Proposed Change 1880

Code Reference(s):	NBC20 Div.A 2.1.1.2. (first printing)
Subject:	Accessibility, Visitability and Adaptability of Dwelling Units
Title:	Expanding the Application of the Accessibility Objective to All Dwelling Units
Description:	This proposed change removes the exemption for houses from the application of the accessibility objective.
Related Proposed Change(s):	PCF 1881, PCF 1883, PCF 1957, PCF 2028

Proposed Change 1976

Code Reference(s):	NBC20 Div.B 1.1.3.1. (first printing) NBC20 Div.B Appendix C (first printing)
Subject:	Earthquake Load and Effects — Seismicity
Title:	Update of Seismic Hazard in Northwestern Canada
Description:	This proposed change addresses a known issue in the NBC 2020 seismic hazard values for parts of northwestern Canada and updates Note A-1.1.3.1.(4) and Appendix C to reference the 2025 National Building Code of Canada Seismic Hazard Tool.

Figure [A-1.1.3.1.(4)] A-1.1.3.1.(4)
Determining seismic hazard values for use in Part 4 and Part 9

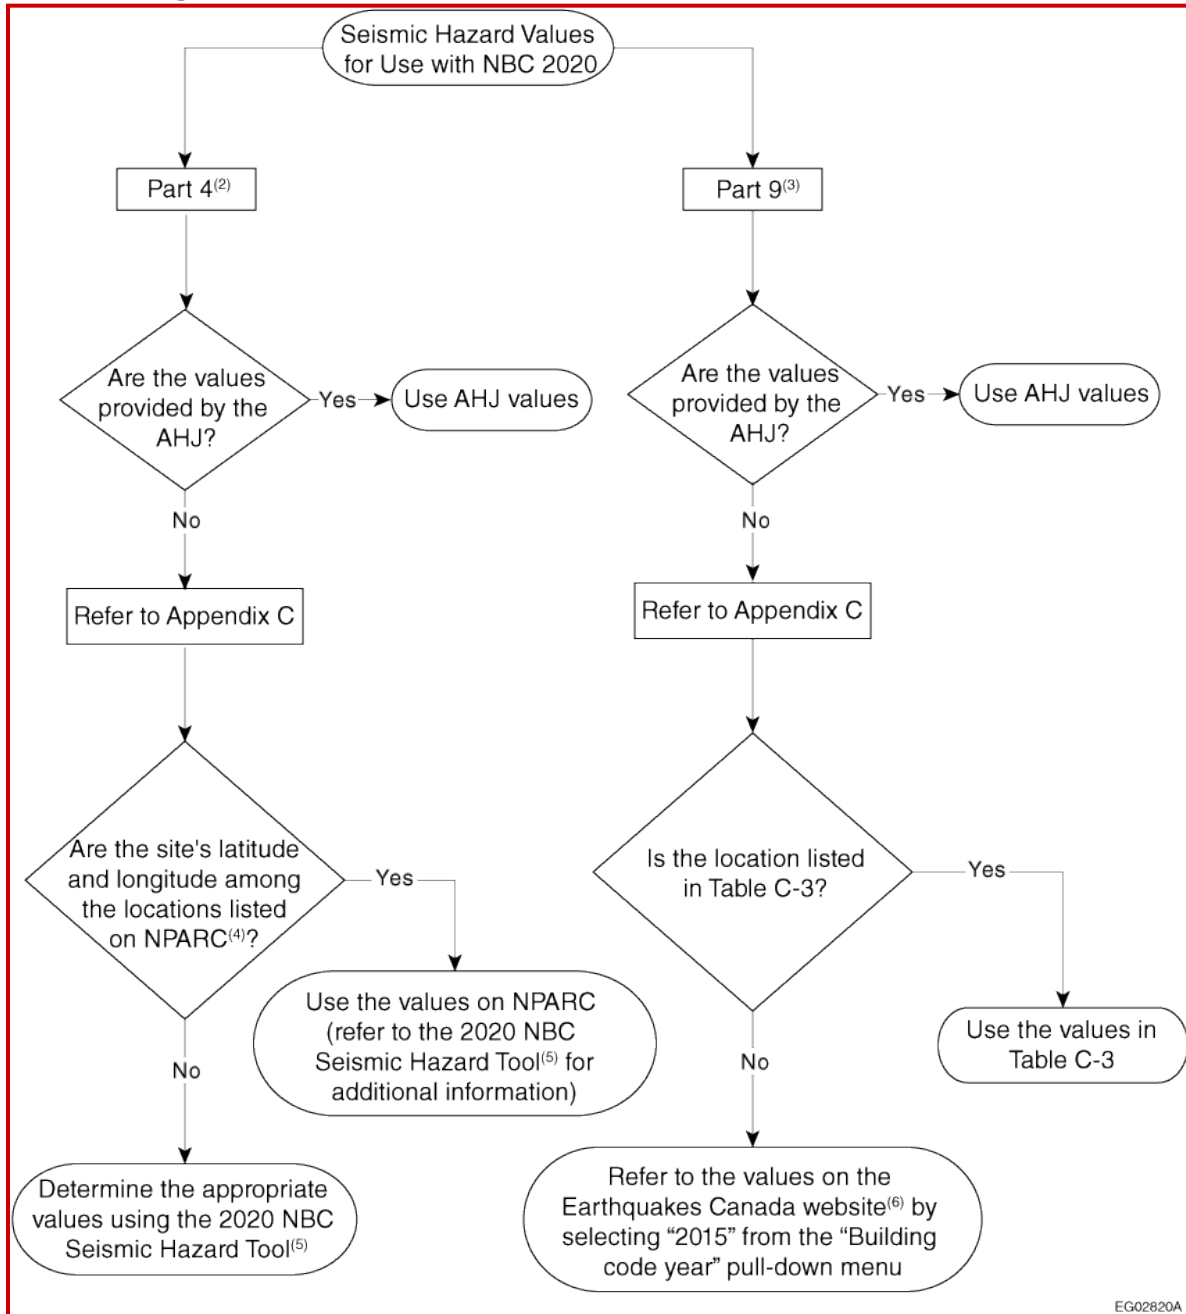
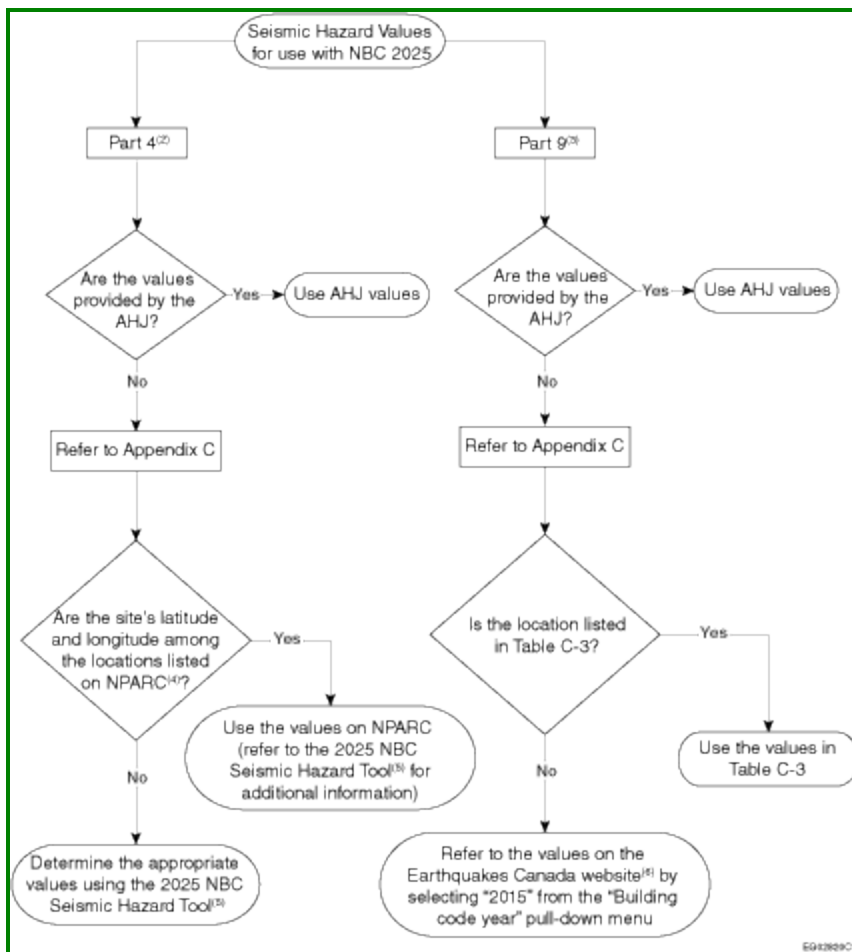
The proposed change addresses the issue of overly high seismic hazard values in parts of northwestern Canada. The adoption of updated values, which are lower than the current ones, may reduce the construction costs in these localities.

The proposed change also addresses the issue of inappropriate seismic hazard disaggregations for parts of northwestern Canada. Natural Resources Canada corrected this issue after the publication of the NBC 2020 and released an updated seismic hazard model referred to as CanadaSHM6.1. It is important to implement the updated CanadaSHM6.1 model in the NBC 2025 for consistency so that the seismic hazard model referenced in the Code is the most current model and the only model applicable in the country.

The proposed change implements this update. It also updates Note A-1.1.3.1.(4) and Appendix C to reference the 2025 National Building Code of Canada Seismic Hazard Tool.

Figure A-1.1.3.1.(4) illustrates how to determine the seismic hazard values to be used in the application of the Part 4 and Part 9 seismic provisions.

Figure [A-3.4.6.5.(3)-A]
Stair where an intermediate handrail is not required by Clause 3.4.6.5.(3)(a)

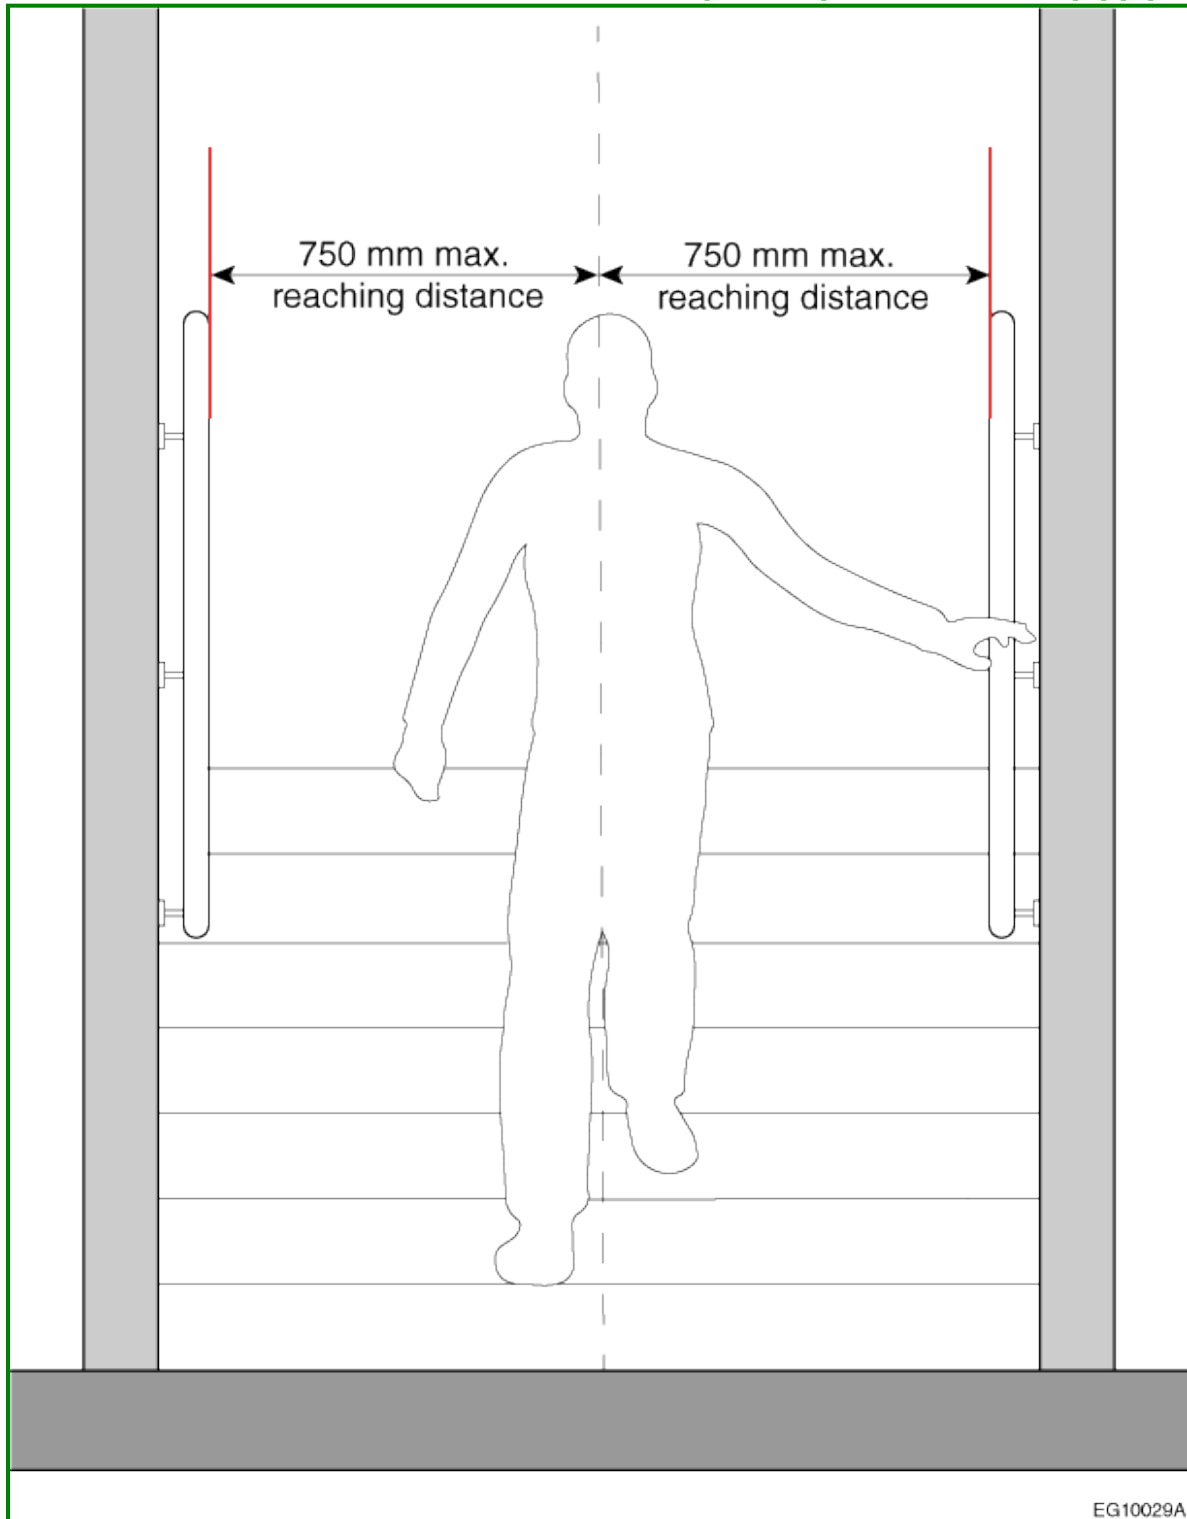
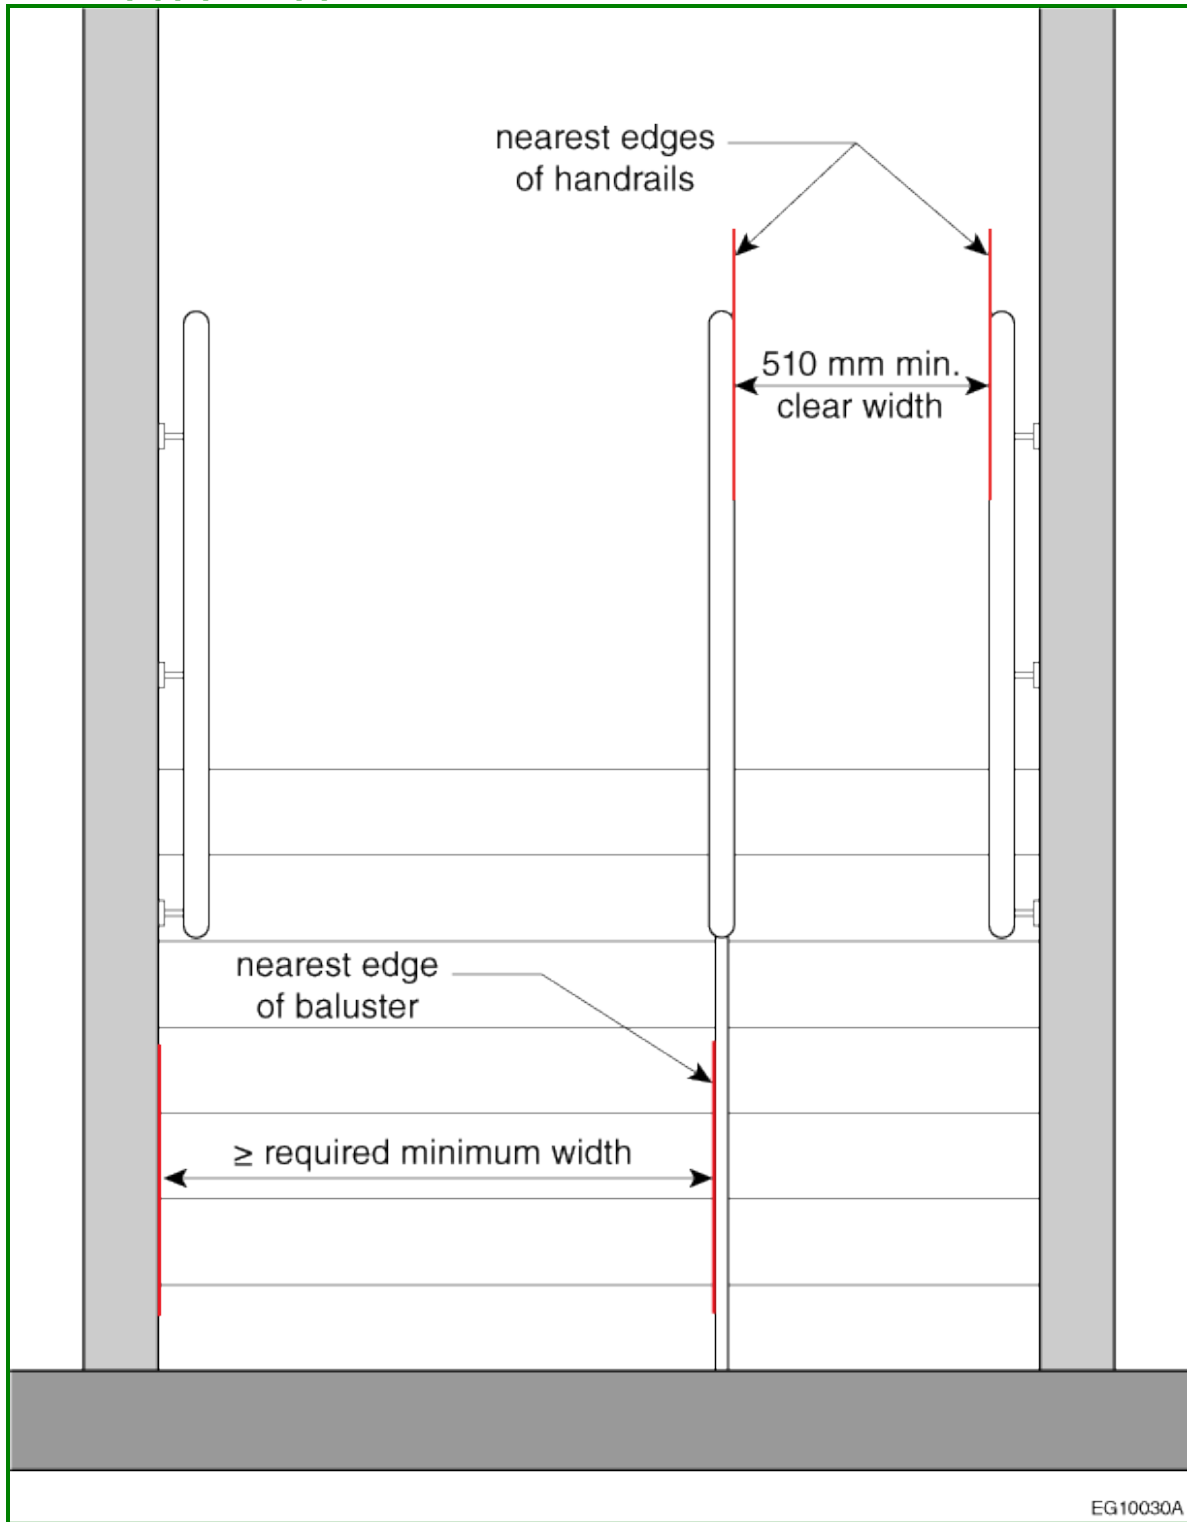
This proposed change also introduces explanatory Note A-3.4.6.5.(3) to clarify where the intermediate handrail is required by Sentence 3.4.6.5.(3) and how to measure the relevant dimensions. Additionally, two figures are provided to illustrate where an intermediate handrail is not required and where a handrail is required.

Figure [A-9.36.7.3.(9)] A-9.36.7.3.(9)
Determining the appropriate airtightness value to use in the energy model calculations in the tiered energy performance compliance path

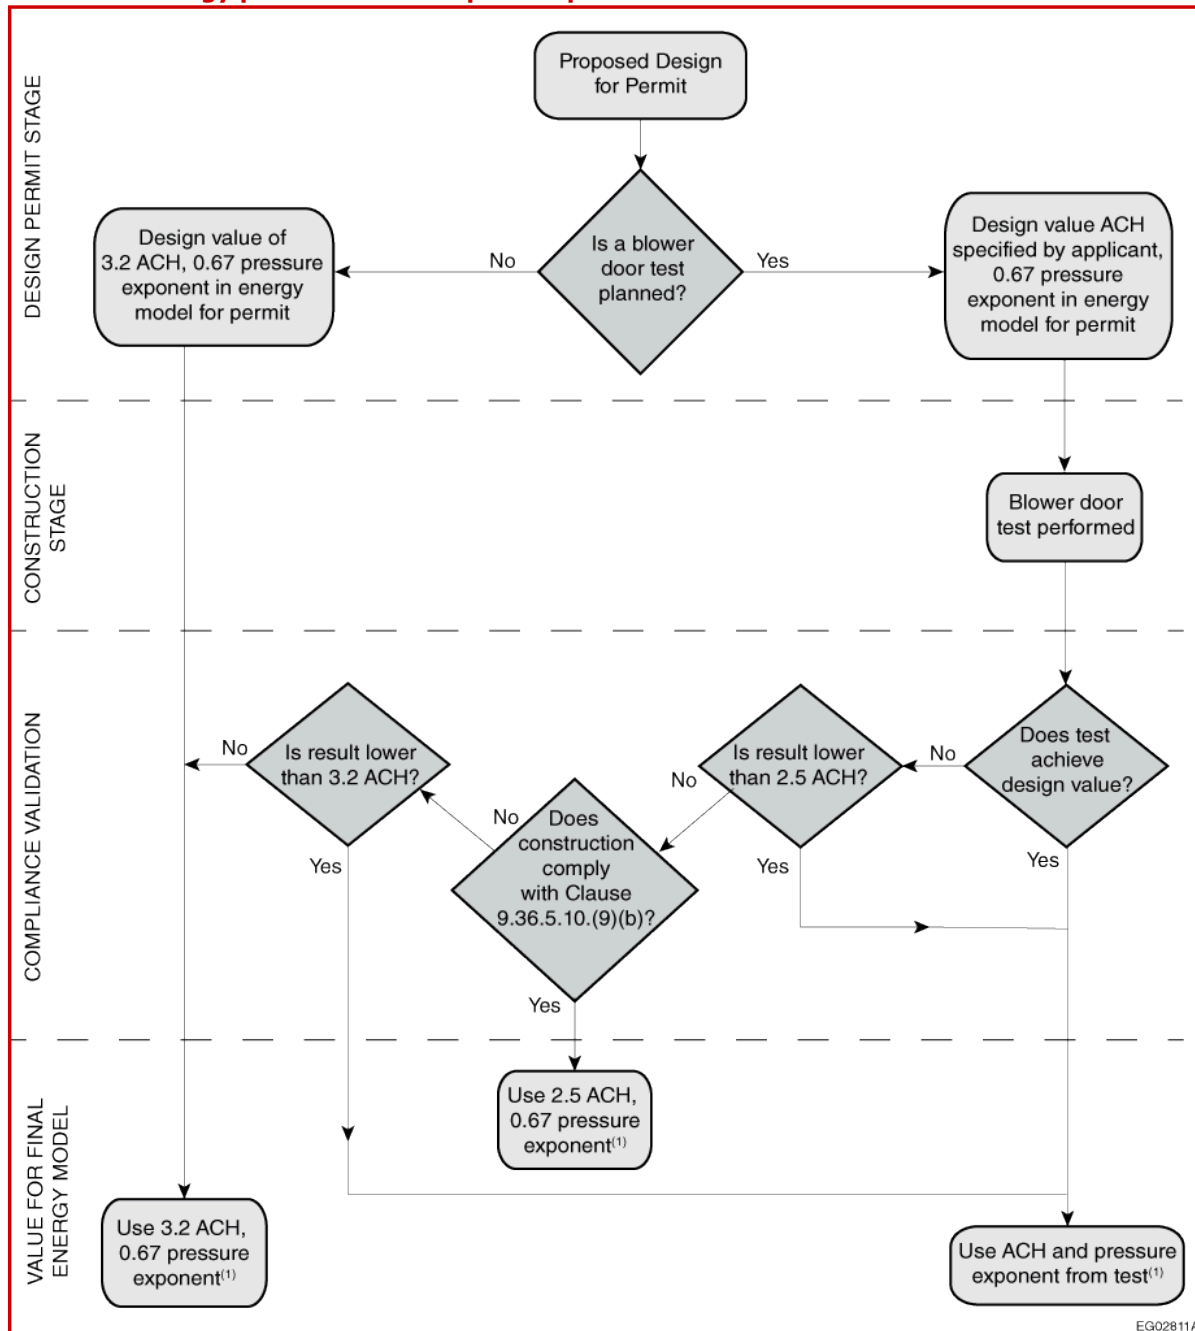
~~The flow chart in Figure A-9.36.7.3.(9) outlines the intended interpretation of Sentence 9.36.7.3.(9). Airtightness testing is voluntary, however, not testing will result in the proposed house model using a default airtightness of 3.2 air changes per hour (ACH) at 50 Pa pressure difference and a pressure exponent of 0.67. If performed, airtightness testing provides the option of using the result instead of the prescribed airtightness value in the modeling of the proposed house. Testing the airtightness of a building will lead to more certainty regarding the building's energy performance, which is more important for compliance with higher-tier targets.~~

**Figure [A-2.4.6.6.(1)]
Parapet height**

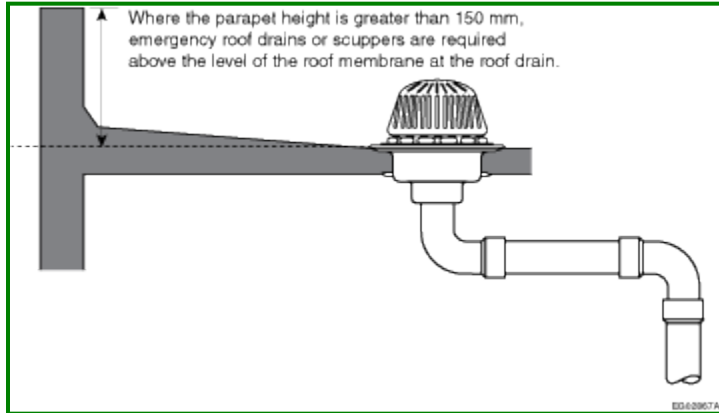
Note A-2.4.6.6.(1) Parapet Height.

Storm building drain serving both the primary and emergency roof drainage systems

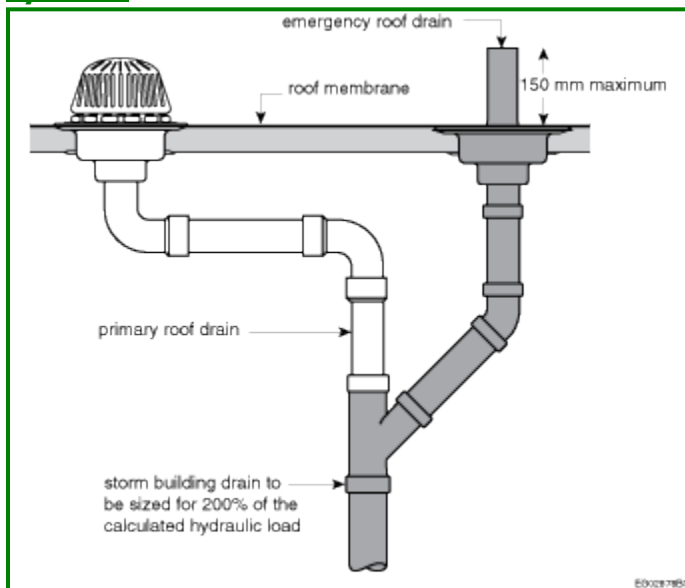
Note A-2.4.10.4.(5) Storm Building Drain Serving Both the Primary and Emergency Roof Drainage Systems.
